Re: Burque Bakehouse

640 Broadway Blvd SE Traffic Circulation Layout

Engineer's/Architect's Stamp 09-23-2019 (K14D119)

Layout

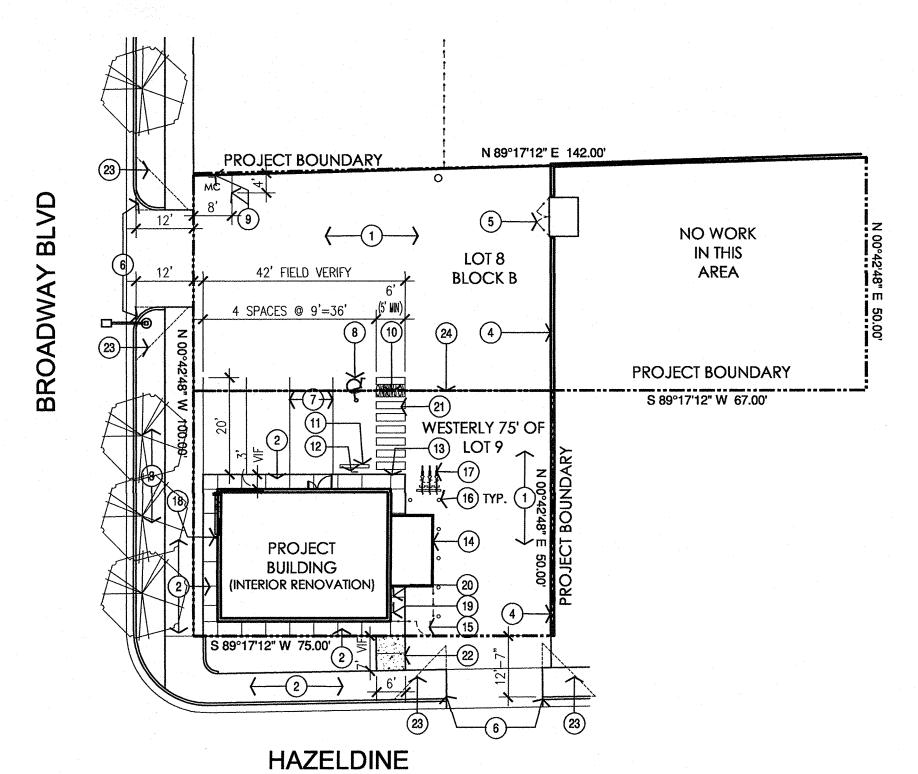
The TCL submittal received 09-24-2019 is approved for Building Permit with the condition of re-plat in progress. The Co will not be release before a re-plat is complete. A copy of the stamped and signed plan will be needed for each of the building permit plans. Please keep the original to be used for certification of the site for final C.O. for Transportation.
